**U.S. Army Corps
of Engineers**
Engineering and Support
Center, Huntsville

Pershing Child Development Center

**Building 1140
Fort Eustis, VA**

**POTR – Phase 1
Project No 69811**

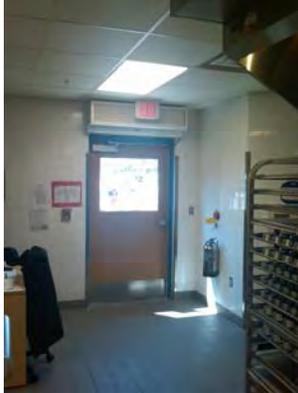
- Door into the toilet area and into the Storage Room in the Active Play Room are less than 36" wide.

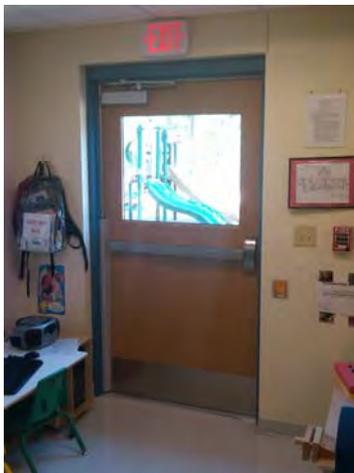
- Door hardware into toilets do not comply with ABA/ADA. Lever hardware was not provided – these are

actual door knobs.

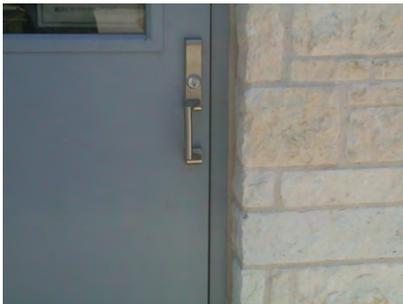
- The corners of the ABA toilet stalls in the Pre-school/Pre-K/Kinder rooms are not braced overhead, but they have been firmly attached to the floor, and at this time do not have much deflection.

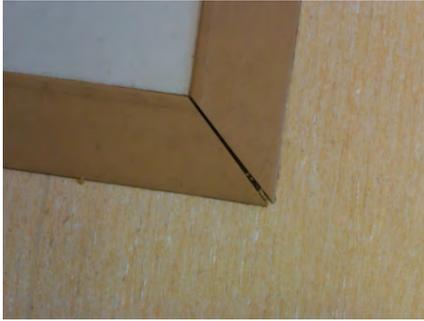
- The transition strips between the ceramic tile floor of the toilet areas and the seamless vinyl flooring of

the Activity Room is separating.

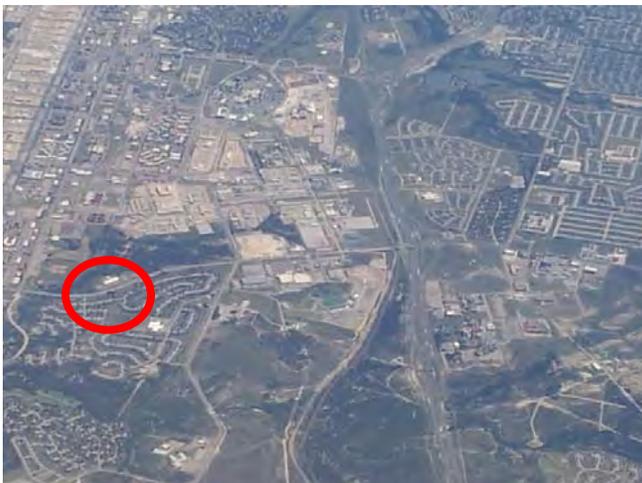
- In some areas of the playground, the ground is significantly below the level of the sidewalk, and in some areas the sprinkler pipes have been exposed. These areas need to be filled and sodded.
